CONTRACT CHANGE ORDER NO. ____
SHEET ___ OF ___

MARK	DATE	DESCRIPTIONS	BY	CH'D	CCO#
5	01/27/12	EMERGENCY ACCESS RAILING MODIFICATIONS	HT	TH	231
4	11/12/10	BIKEPATH HANDRAIL MODIFICATIONS	TH	JD	169
3	08/20/10	BIKEPATH DETAILS	TH	MN	99
2	11/26/08	BIKEPATH DETAILS	TH	MN	99
1	09/07/07	MECHANICAL MODIFICATIONS	JD	TH	31

SAN FRANCISCO OAKLAND BAY BRIDGE
EAST SPAN SEISMIC SAFETY PROJECT
SELF-ANCHORED SUSPENSION BRIDGE
(SUPERSTRUCTURE & TOWER)

RAILING LAYOUT NO. 3

DETAIL G
1:20
(EMERGENCY ACCESS RAMP AT PP 123)

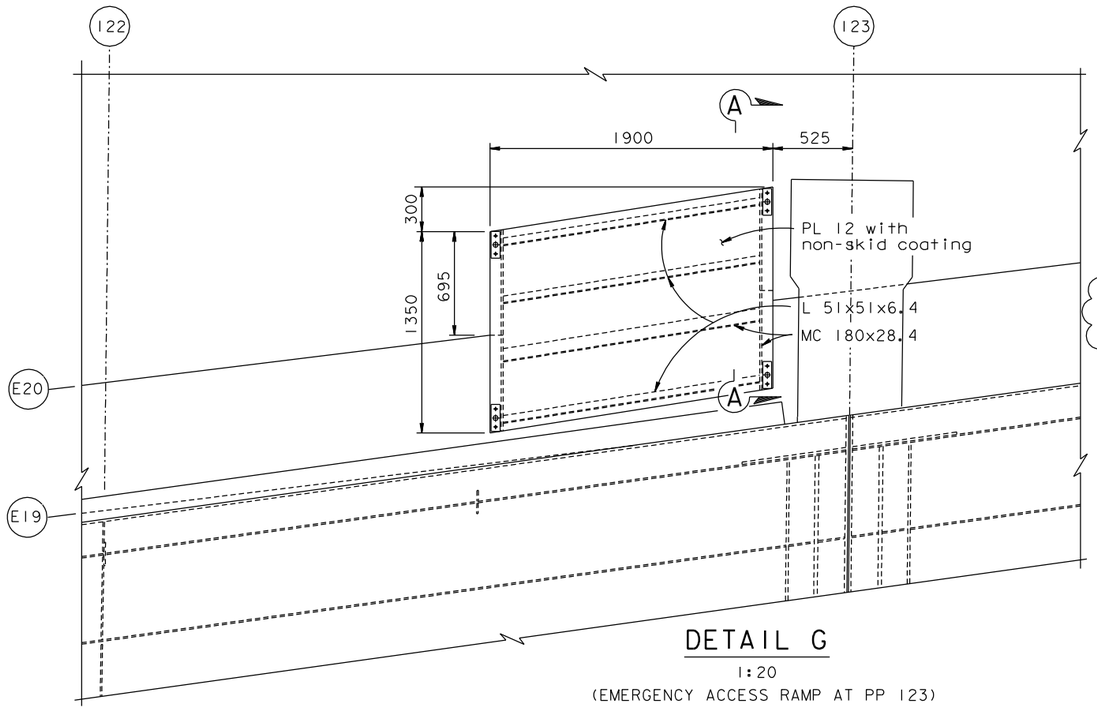
MARK	DATE	DESCRIPTIONS	BY	CH'D	CCO#
1	01/27/12	EMERGENCY ACCESS RAILING MODIFICATIONS	HT	TH	231
0	11/26/08	BIKEPATH DETAILS	TH	MN	99

1. For details not shown, see "Railing Layout No.3" sheet.
2. For Sections B-B, C-C, D-D and E-E, see "Railing Layout No.3B" sheet.
3. The top of PL 8 on bikepath railing post shall align with the top of upper 38 Dia pipe. The bottom of PL 8 on bikepath railing post shall align with the bottom of lower 38 Dia pipe.
4. Finish paint all PL 8 and angle extension PL.

RAILING LAYOUT NO. 3B

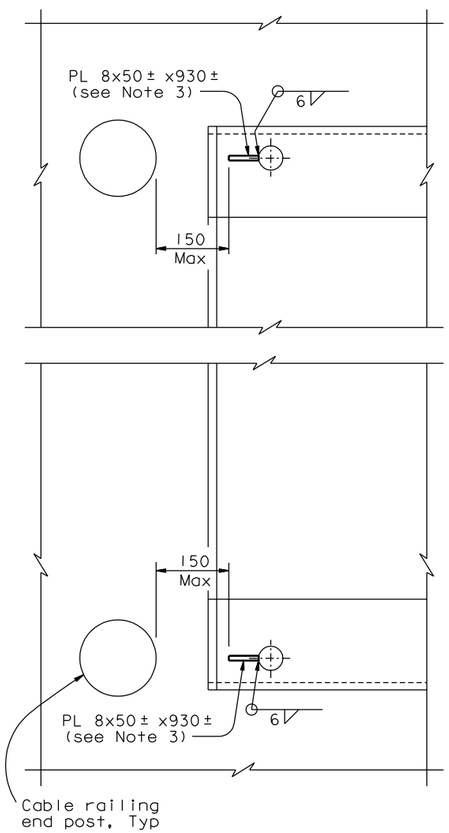
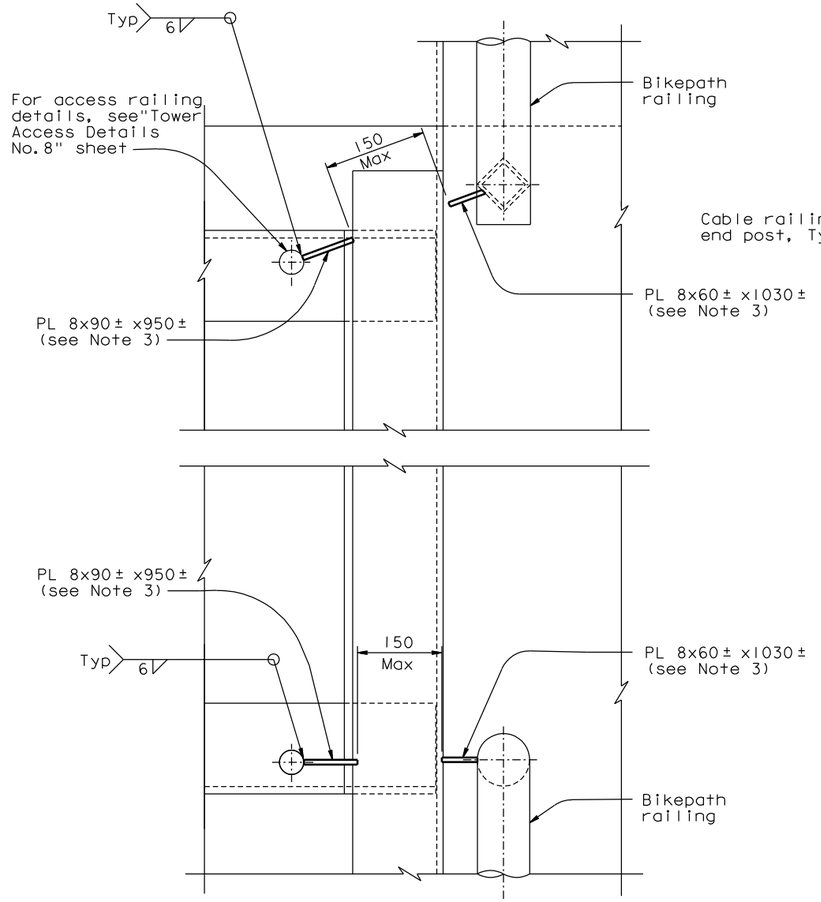
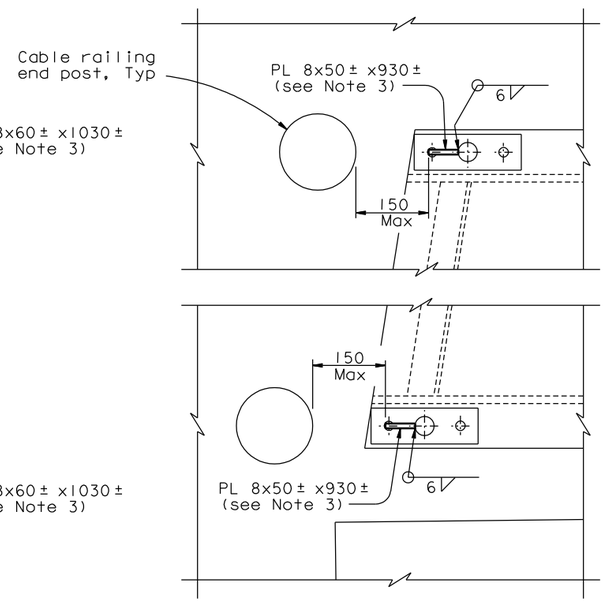
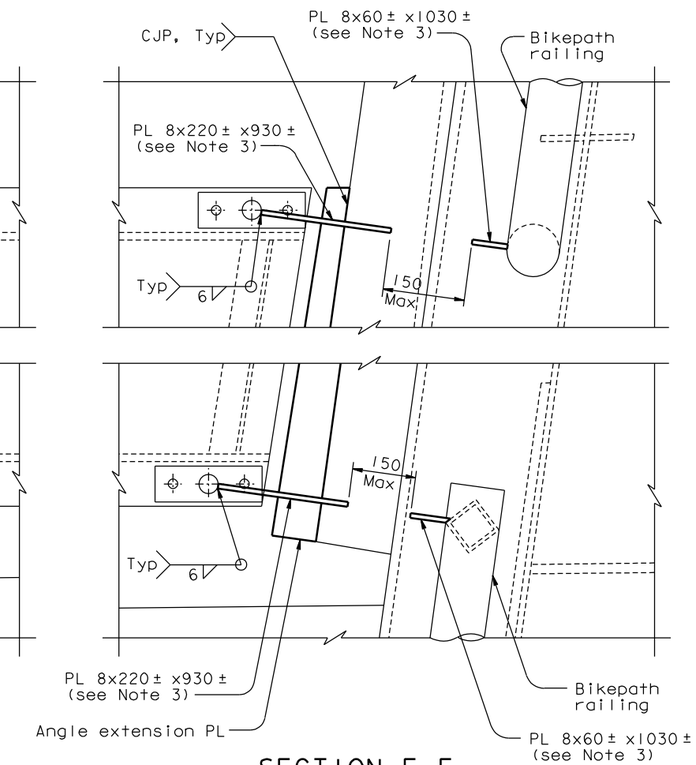
MARK	DATE	DESCRIPTIONS	BY	CH'D	CCO#
0	01/27/12	EMERGENCY ACCESS RAILING MODIFICATIONS	HT	JD	231

1. For details not shown, see "Railing Layout No. 3" sheet.
2. PL 8 edges shall be ground smooth.
3. Dimensions of PL 8 shall be adjusted to achieve a gap of 150 Max.
